Re: Sand Filter Survey

ET WALL LEISURE CENTRE
FILTER WALL THICKNESS
ULTRASONIC TEST RESULTS
ALL DIMENSIONS IN MM
SURVEY DATED 29.6.04

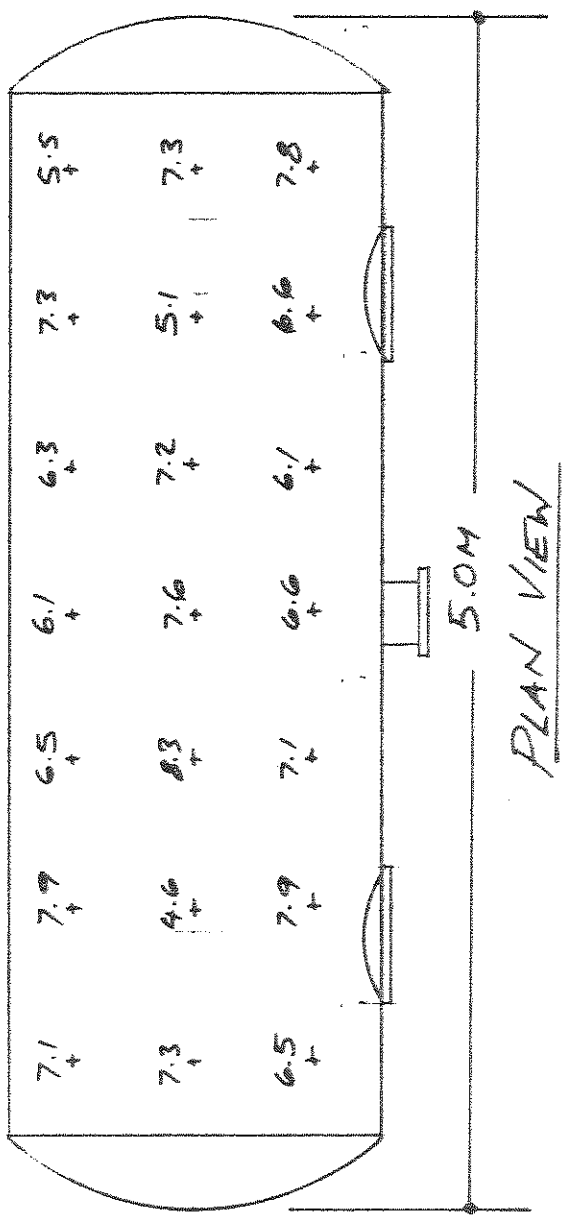
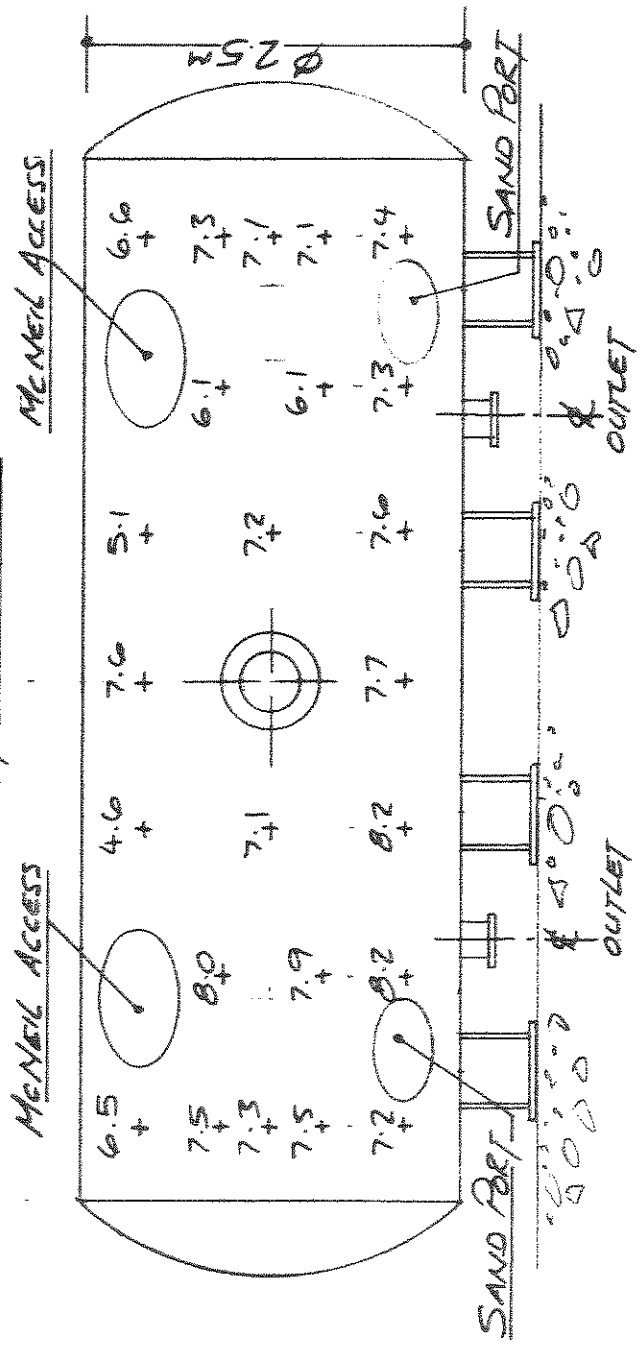
Further to recent ultrasonic testing of your swimming pool sand filter vessel, please find enclosed, marked up drawing highlighting the mild steel wall thickness taken at random points about the filter body.

Readings taken during our survey indicate that the average thickness of the sidewalls is 8.06mm and 8.48mm at the dished ends. The thinnest reading of 4.6mm to the sidewall is slightly worrying and we strongly recommend that this ultrasonic procedure be carried out annually. This will determine any pattern of deterioration in the steel and offer a measure in timescale to work with.
